(R) BOLT, MACHINE - HEXAGON HEAD, FULL SHANK, CORROSION RESISTANT STEEL (UNS S17400), 140 KSI MIN UTS, .6250-18 UNJF-3A

AS9790
SHEET 1 OF 2

REV. A

ISSUED 1999-08 REAFFIRMED 2005-05 REVISED 2014-10

FIGURE 1 - BOLT

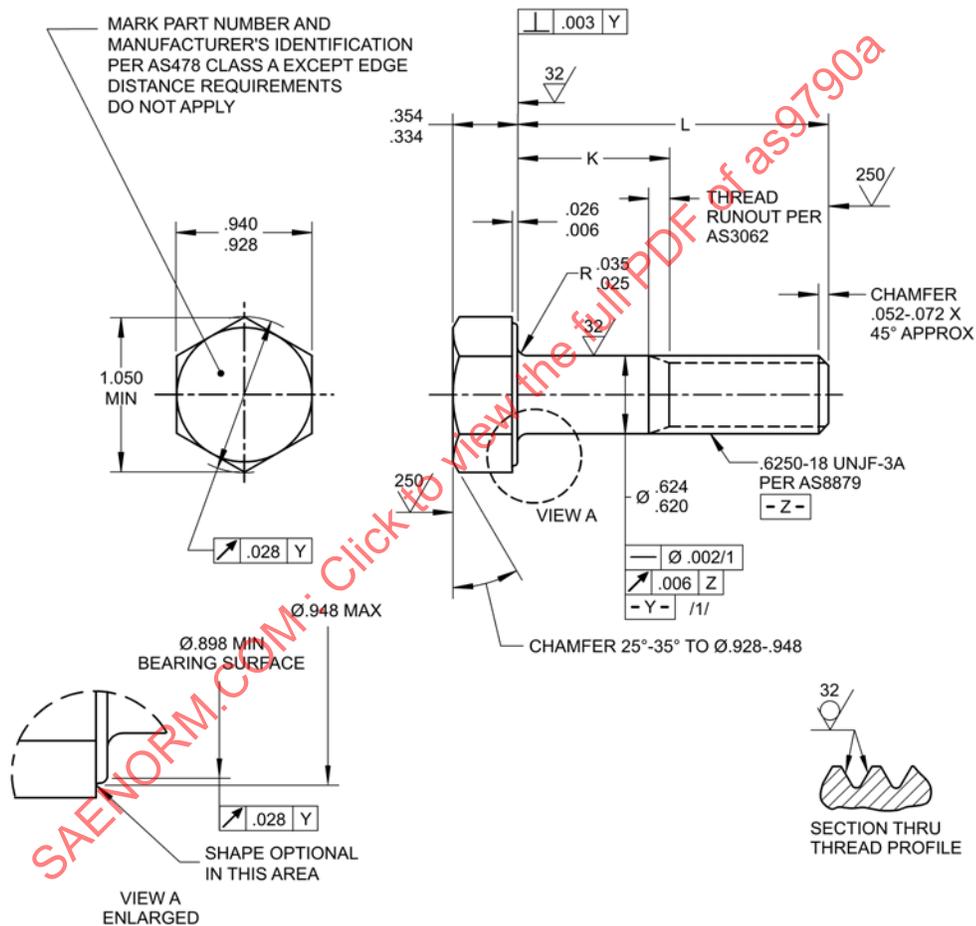
UPDATE THREAD SPECIFICATION TO AS8879, UPDATE TO ANSI Y14.5M-1982, REVISE FPI REQUIREMENTS TO ASTM E1417/1417M, ADD EDGE DISTANCE EXCEPTION FOR HEAD MARKING, REVISE ACROSS POINTS DIMENSION, ADD AS3062 FOR THREAD RUNOUT, CONVERT GD&T NOTES TO FEATURE CONTROL FRAMES, DATUMS, AND SYMBOLS, ADD SURFACE TEXTURE REQUIREMENTS FOR TOP AND END, ADD SURFACE TEXTURE SYMBOLS PER ASME Y14.36M, FIGURE 1 REDRAWN AND GENERAL EDITORIAL UPDATE.
